Access Compliance Report

Public Rights-of-Way

Intersection ID: 32276	Main Street: SULLIVAN_RIDGE_DR	Cross Street: WILLOUGHBY_RUN_DR	Location: SE
ADA ID: CBC9BDBB24F3	Ramp Type: PerpDiag	Initial Pass/Fail: Fail	Overall Compliance: No
Severity Score: 21.25			
Codes/Mitigation Info/Possible Solution		Field Measurements/Component Compliance

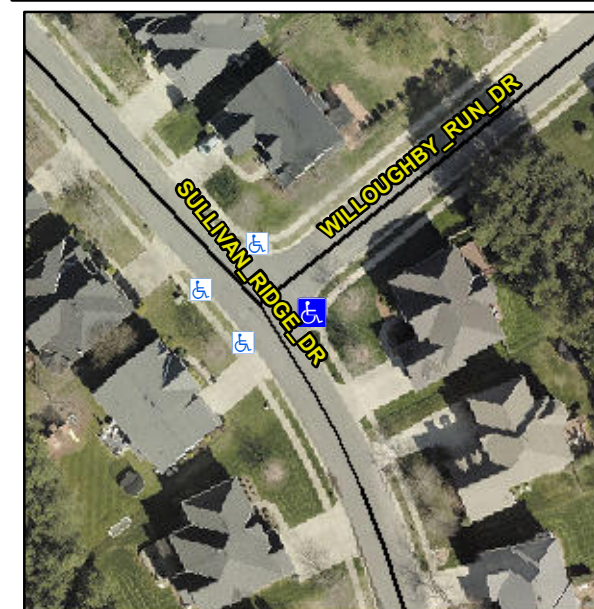
Not Found, R304.5.1, R304.5.3

Compliance	Description	Data	Compliance	Description	Data
N/A	Ramp Length (in)	47.5	Yes	Ramp Slope (%)	6.2
No	Ramp Width (in)	41.0	No	Ramp XSlope (%)	5.3
N/A	Flare Type LT	N/A	N/A	Flare Type RT	N/A
N/A	Flare Slope LT (%)	N/A	N/A	Flare Slope RT (%)	N/A
N/A	Flare Traversable LT?	N/A	N/A	Flare Traversable RT?	N/A
N/A	Landing Length (in)	N/A	N/A	DWS Provided?	N/A
N/A	Landing Width (in)	N/A	N/A	DWS Contrast?	N/A
N/A	Landing Slope (%)	N/A	N/A	DWS Length (in)	N/A
N/A	Landing X Slope (%)	N/A	N/A	DWS Full Width?	N/A
N/A	Landing Curb? (Y/N)	N/A	N/A	DWS Offset (in)	N/A
N/A	Shared Landing?	N/A			
N/A	Gutter Ponding?	N/A	N/A	Gutter Slope (%)	N/A
N/A	Gutter Lip Ht (in)	N/A	N/A	Gutter X Slope (%)	N/A
N/A	Painted X Walk1?	No	N/A	Painted X Walk2?	No
	X Walk 1 Direction	To NW		X Walk 2 Direction	To W
N/A	X Walk 1 Width (in)	N/A	N/A	X Walk 2 Width (in)	N/A
	X Walk 1 Slope (%)	1.4		X Walk 2 Slope (%)	0.0
	X Walk 1 X Slope (%)	0.8		X Walk 2 X Slope (%)	1.9

Remove & Replace Curb Ramp With Two New Directional Ramps or Equivalent.
